CREEK BRIDGE RECONSTRUCTION

SQUIRE CREEK BRIDGE
(1.7 MILES NORTH OF HWY. NO. 33)

FOUNDATION INVESTIGATION REPORT
For
The Proposed Squire Creek Bridge
Reconstruction, Hwy. #14
Lot 12, Con. 6
Twp. of Rawdon; Co. of Hastings
District #8 (Kingston) Ontario)
W.O. 72-11078 - W.P. 187-64-2

REVIEW OF DESIGN DRAWINGS:

BORE HOLE LOCATIONS & SOIL STRATA

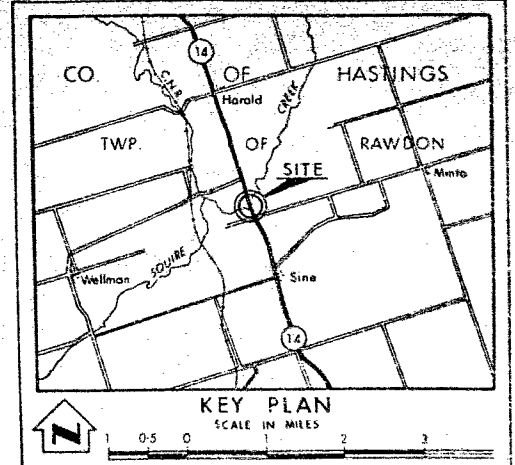
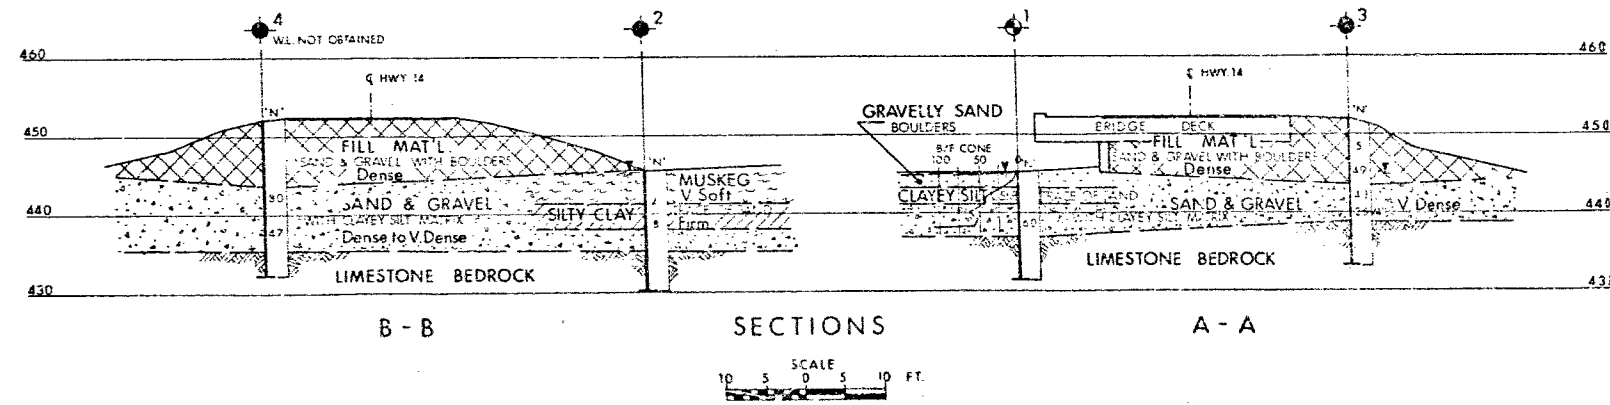
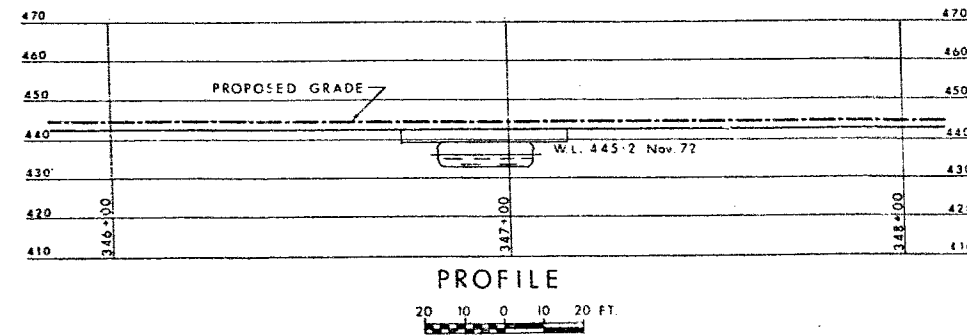
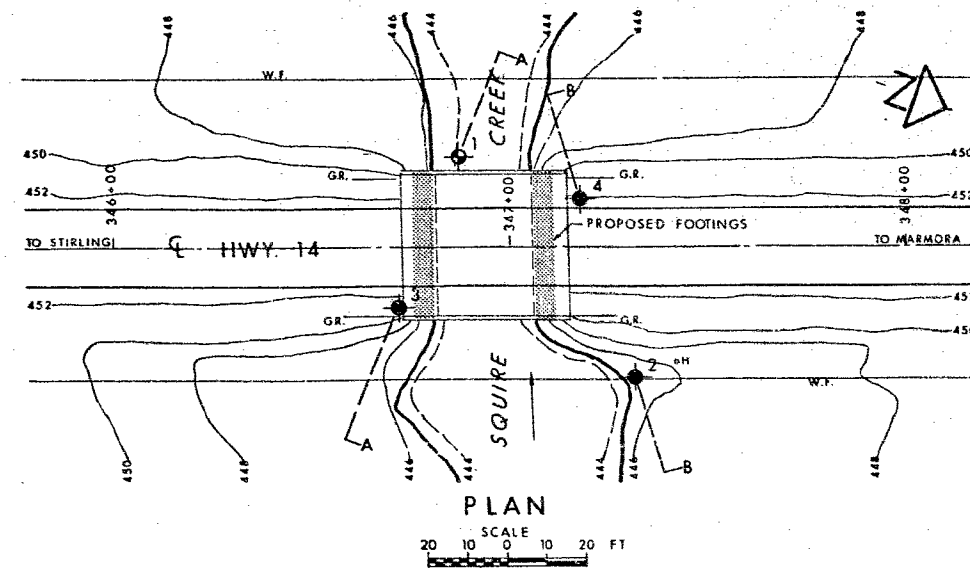
This drawing replaces Site Plan E-4641-1 issued to you with our foundation request on June 20, 1972. The Bore Hole Location and Soil Strata Drawing 72-11078A should be revised to show the revised stations and profile grade.

Structural Office informs us that to date the Bore Hole location and Soil Strata drawing 72-11078A still show stations referred to on E-4641-1 rather than E-5247-1.

We shall be glad if you would revise the Bore Hole location and Soil Strata drawing and distribute copies in the usual manner.

REVISIONS	DATE	BY	DESCRIPTION
1	SEPT 73	DLJ	NEW STATIONS USED, LINE A REMOVED
